ADDENDUM NO. 03

Three Rivers Community Schools District Signage 700 Sixth Avenue Kalamazoo, MI 49093

OWNER THREE RIVERS COMMUNITY SCHOOLS **PROJECT** DISTRICT SIGNAGE PACKAGE A/E Project 5-6405 **ADDENDUM 003 PURPOSE** THIS ADDENDUM SHALL FORM PART OF THE BIDDING DOCUMENTS. CHANGES, ADDITIONS, CLARIFICATIONS OR DELETIONS HEREIN SUPERSEDE THE DRAWINGS AND SPECIFICATIONS. BIDDERS SHALL INCLUDE ON THE PROPOSAL FORM ACKNOWLEDGEMENT OF THE RECEIPT OF THIS ADDENDUM. **ATTACHMENTS New Specifications: None** Reissued Specifications: 10 14 26 New Sheets: C2.06 Reissued Sheets: G0.00, G2.01, C2.01, C2.02, C2.03, C2.04, C2.05 ARCHITECT-ENGINEER **GMB** www.gmb.com 616.796.0200 **CONSTRUCTION MANAGER** THE SKILLMAN CORPORATION www.skillman.com 269.350.5757

DEMOLITION AND SITE PLANS AT ANDREWS ELEMENTARY

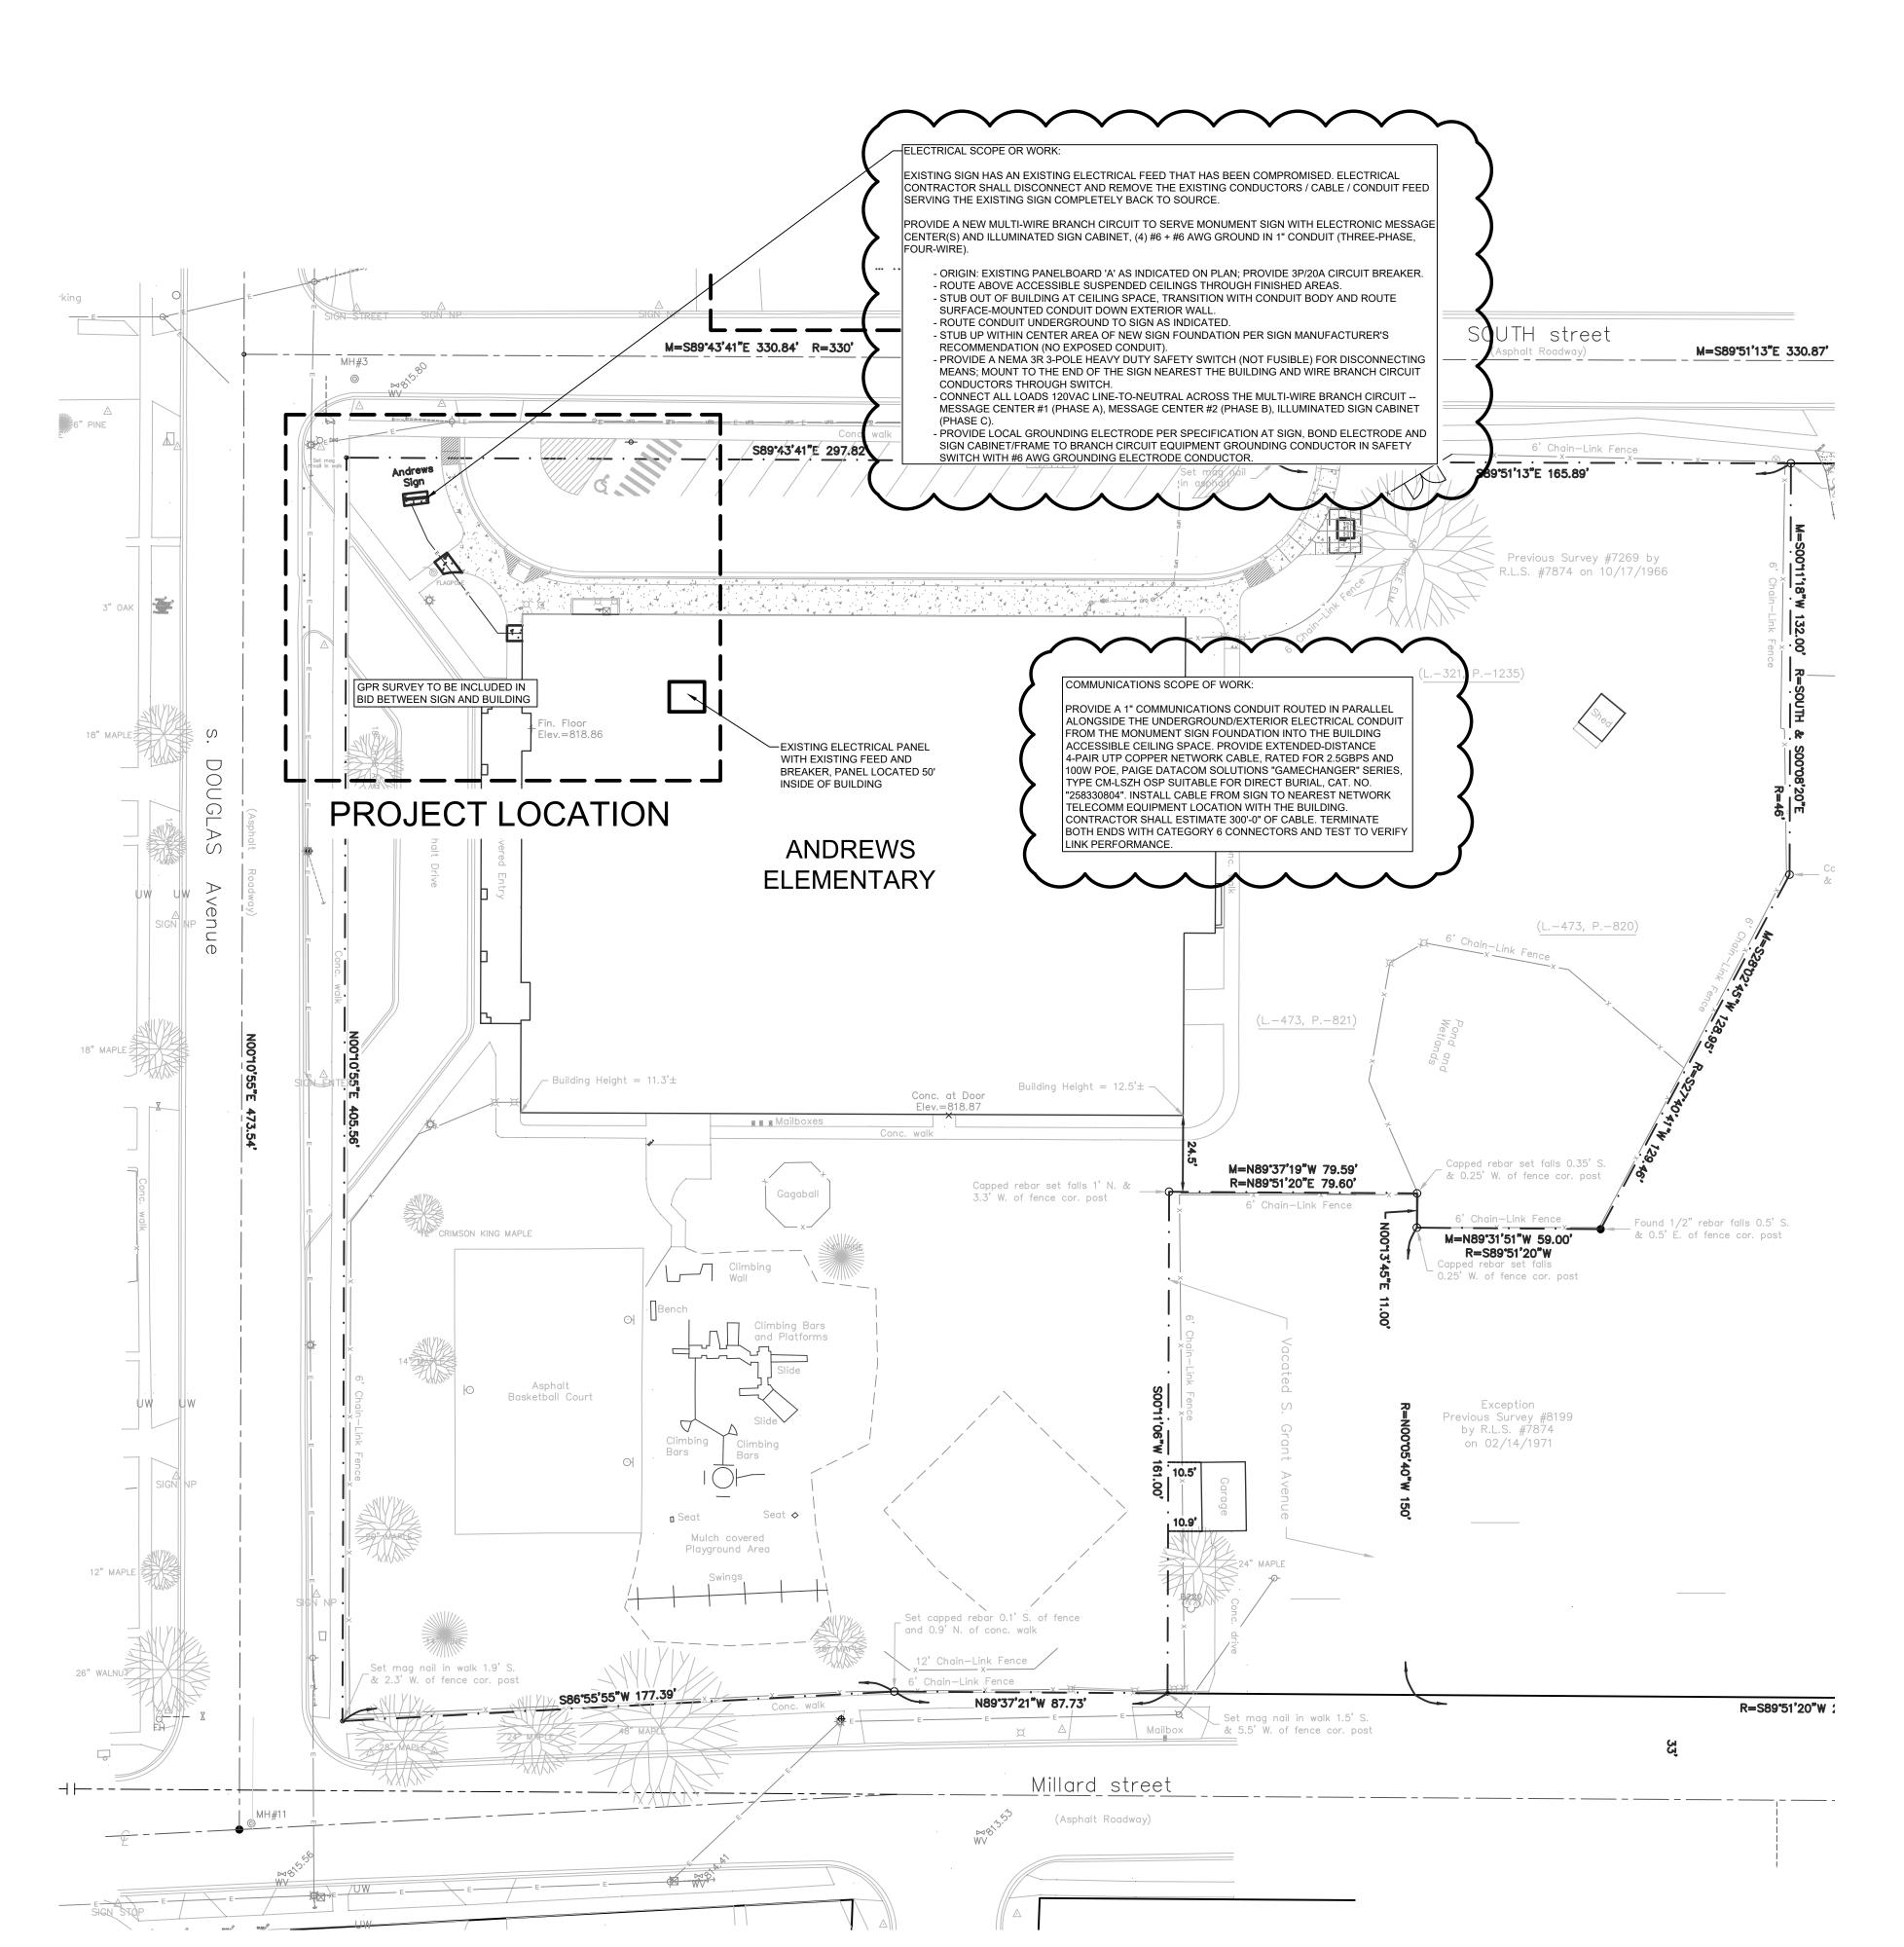
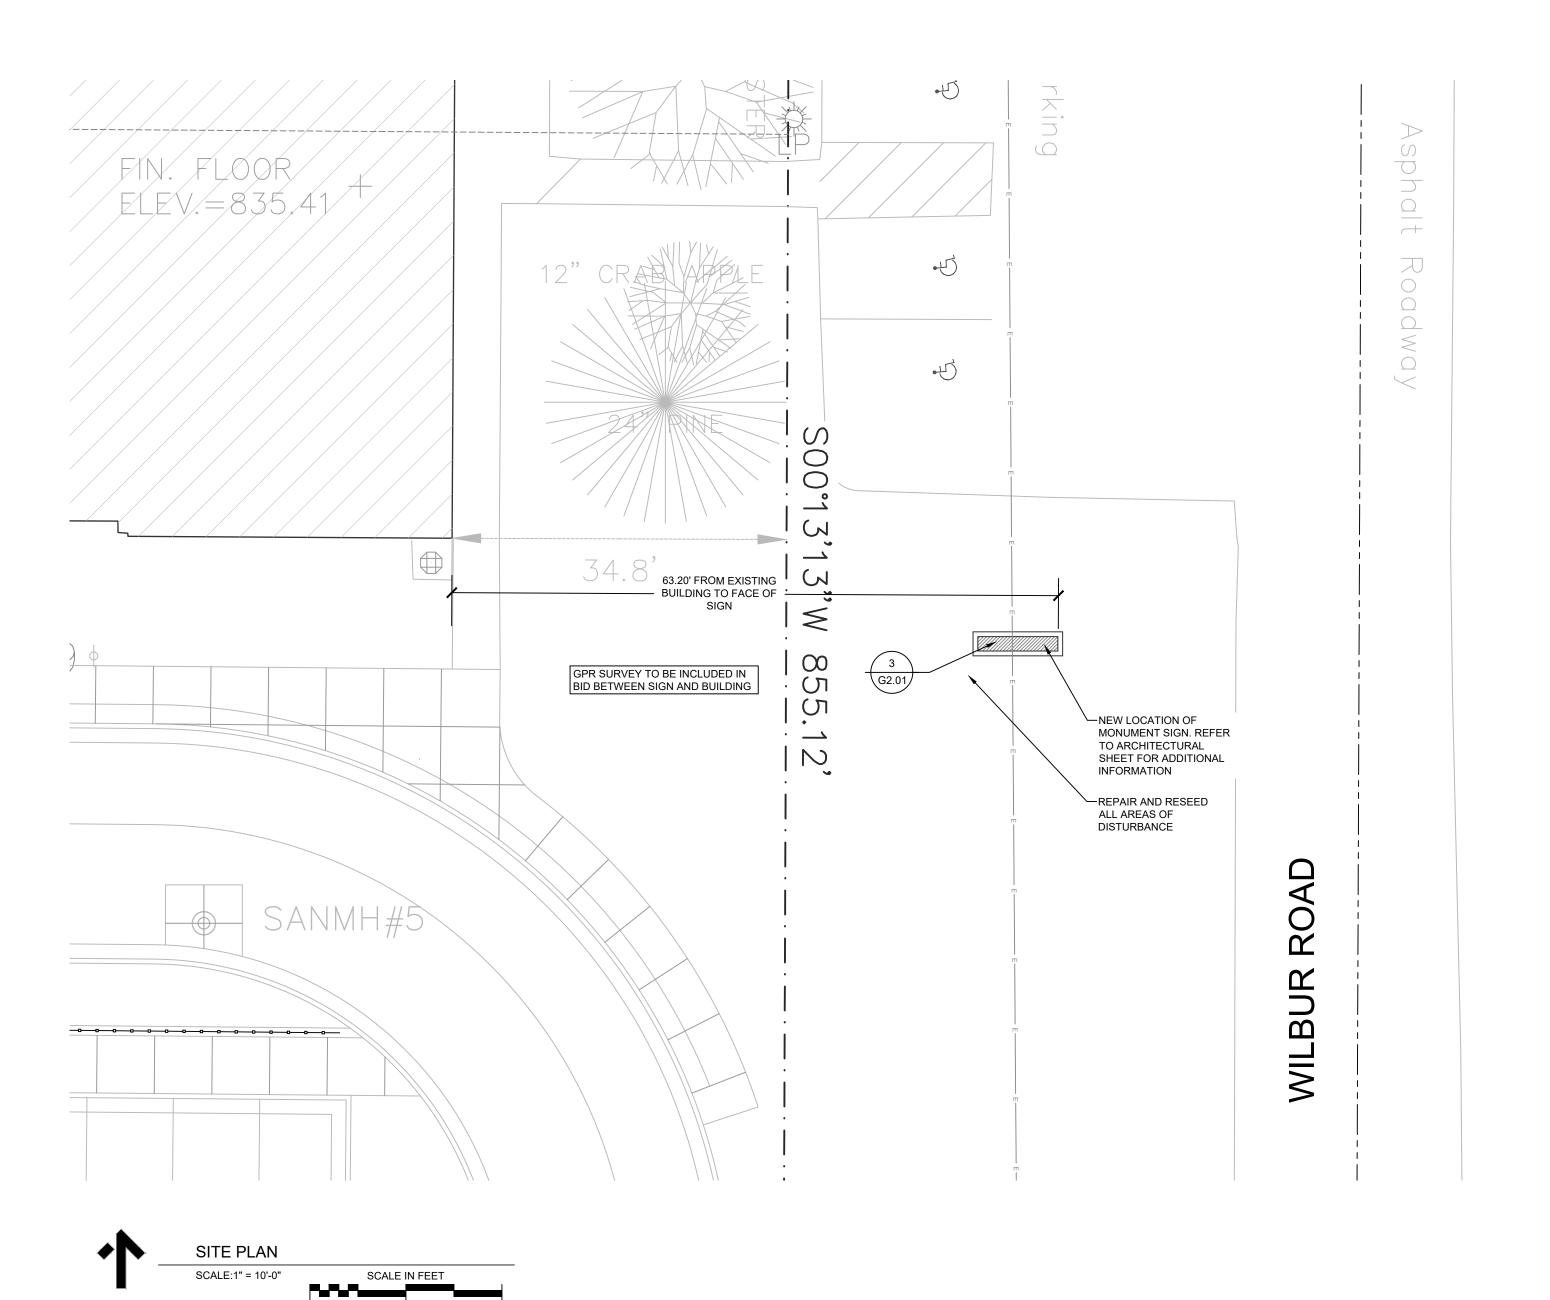
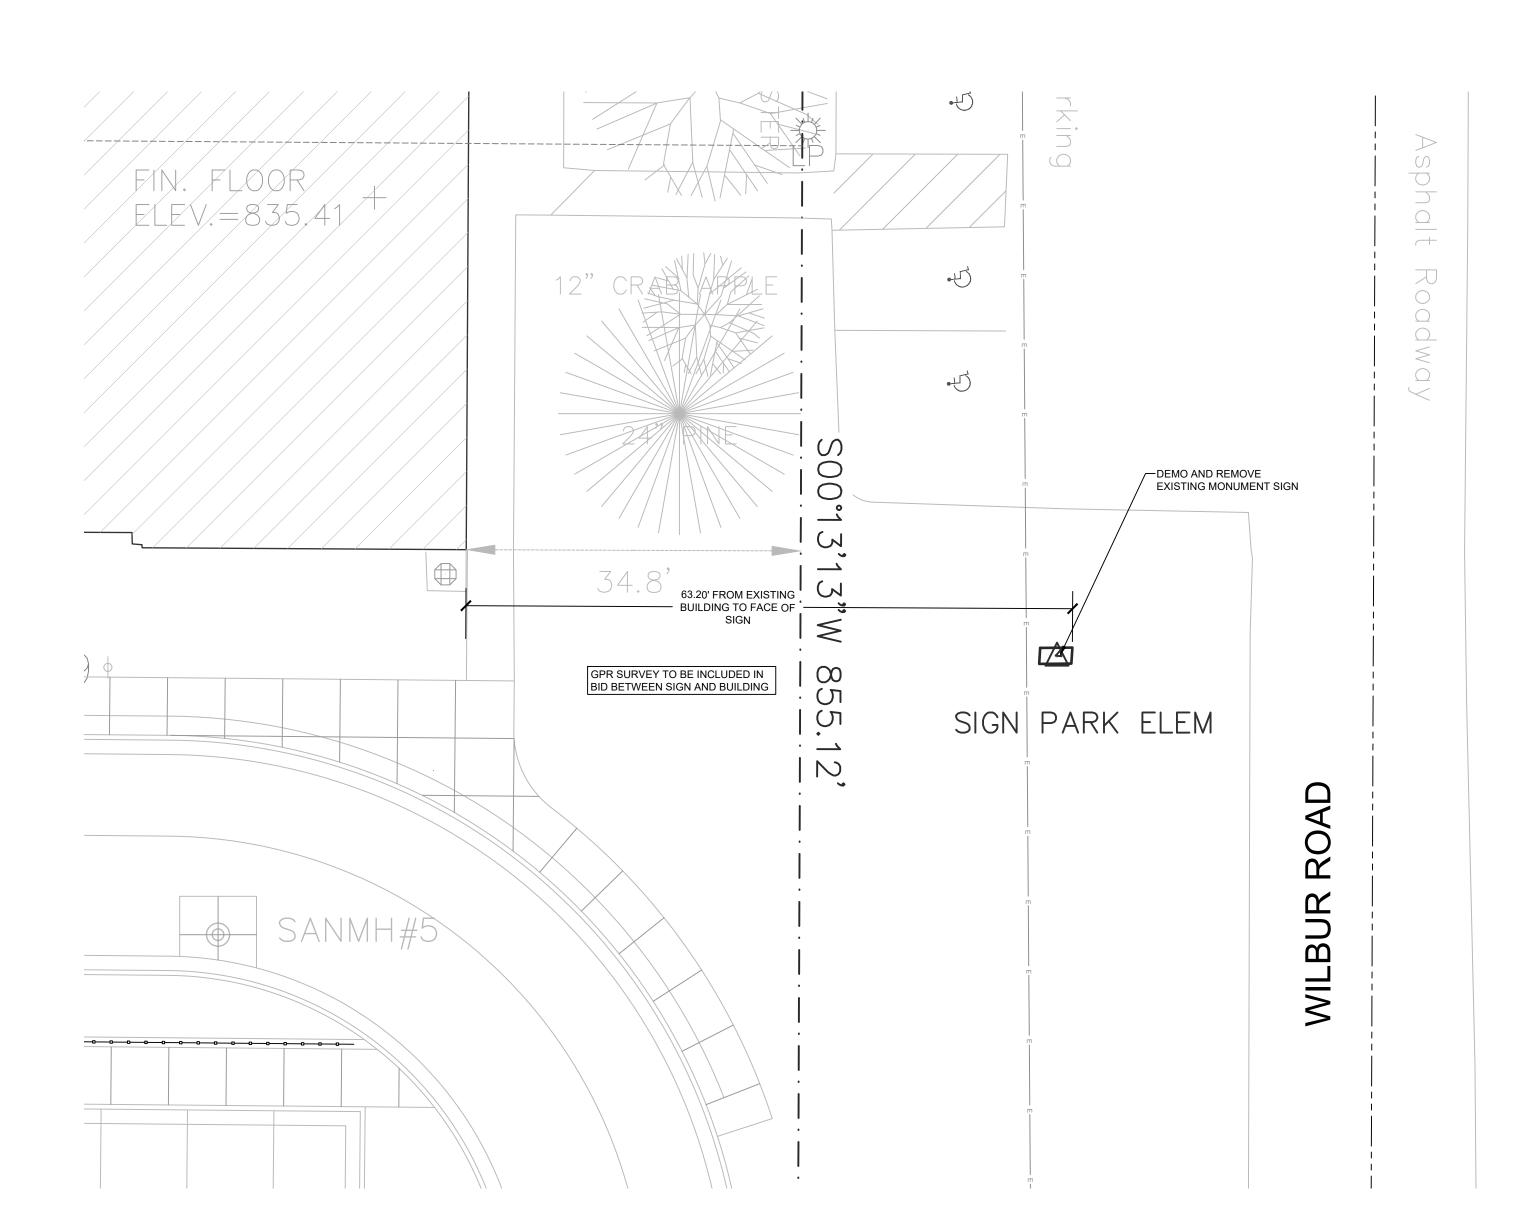
ITEM NO. 5 SHEET C2.02 – DEMOLITION AND SITE PLANS AT ANDREWS ELEMENTARY (REISSUED)

DEMOLITION AND SITE PLANS AT PARK **ELEMENTARY**

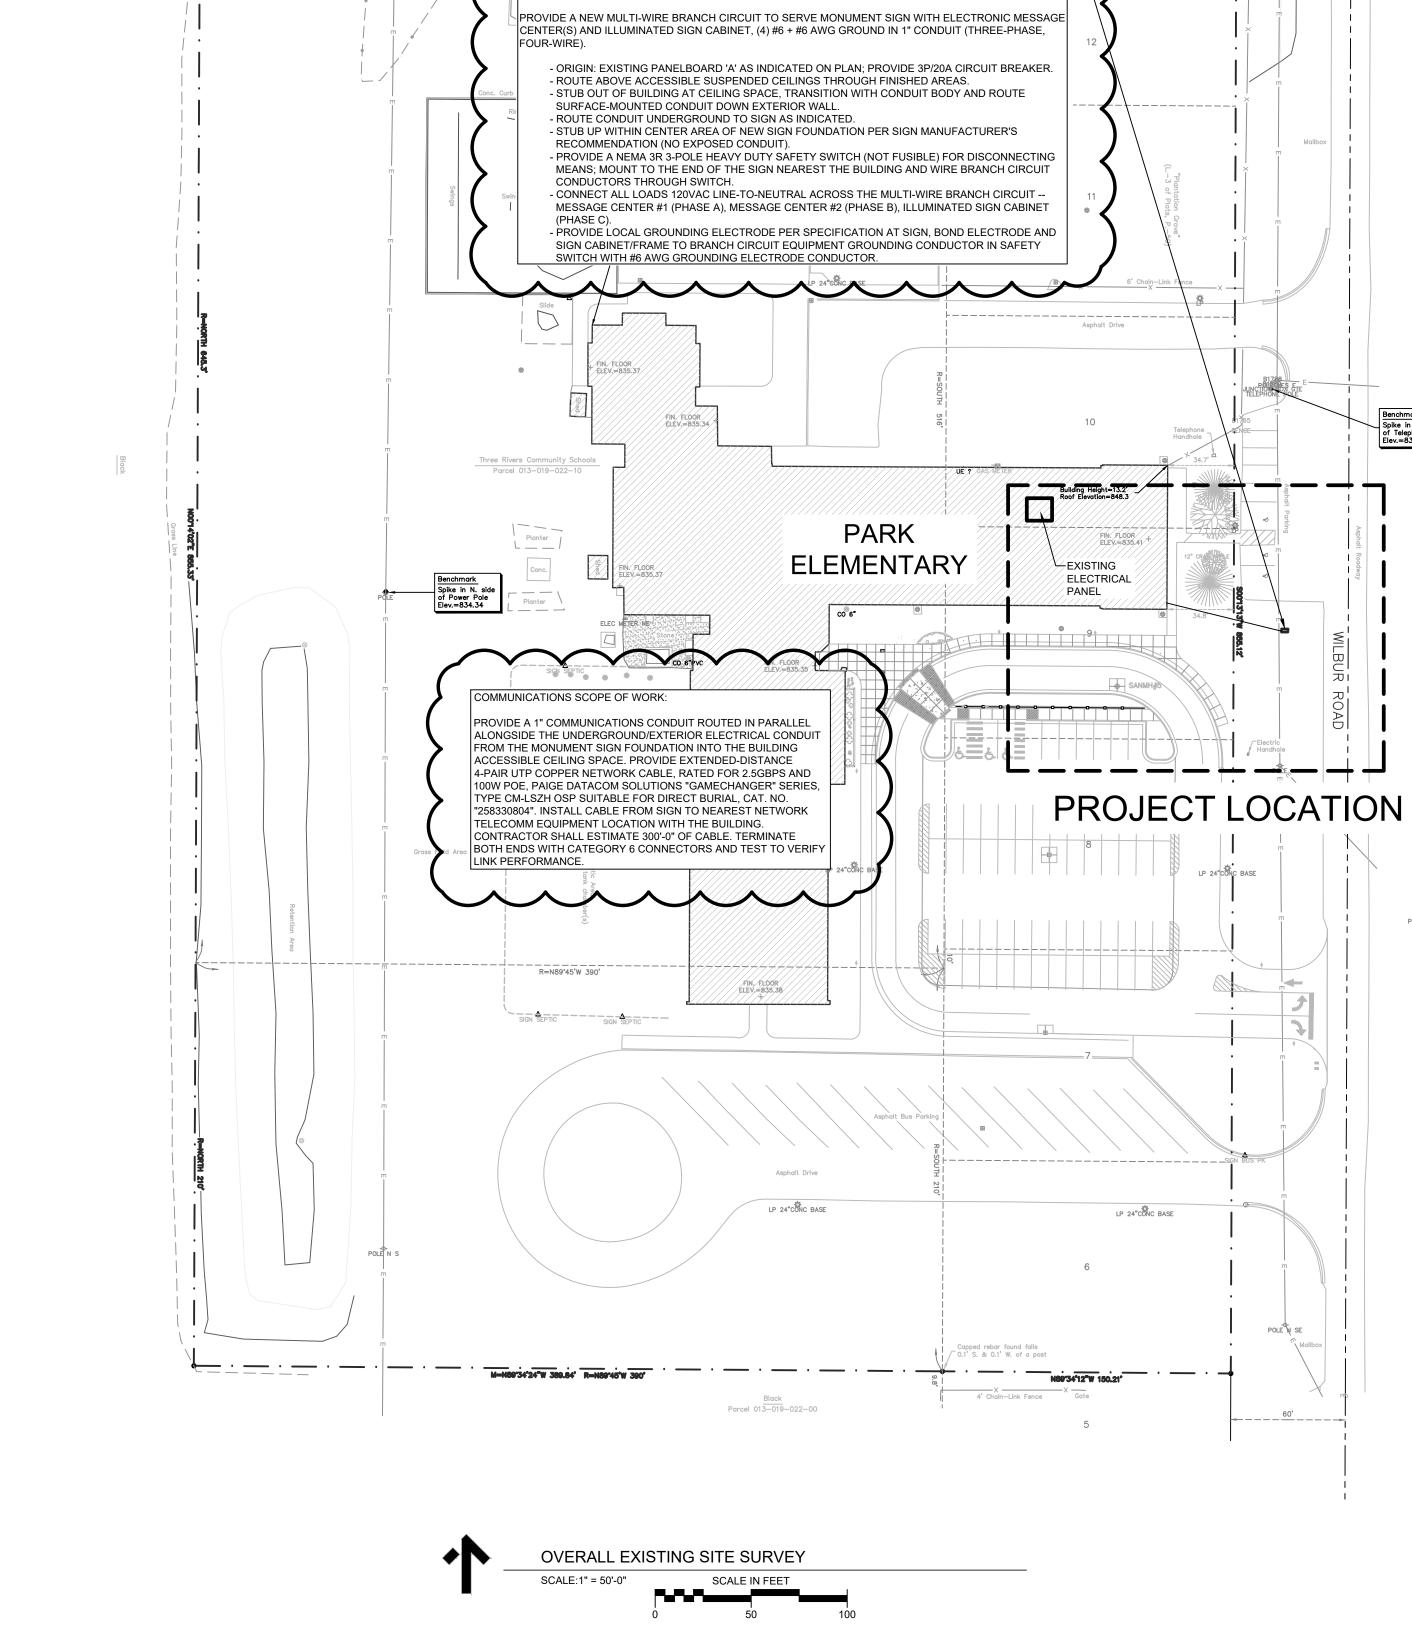
ITEM NO. 6 SHEET C2.03 – DEMOLITION AND SITE PLANS AT PARK ELEMENTARY

Revised electrical and communications requirements to serve monument sign.

EXISTING SIGN HAS AN EXISTING ELECTRICAL FEED THAT HAS BEEN COMPROMISED. ELECTRICAL

CONTRACTOR SHALL DISCONNECT AND REMOVE THE EXISTING CONDUCTORS / CABLE / CONDUIT FEED

SERVING THE EXISTING SIGN COMPLETELY BACK TO SOURCE.
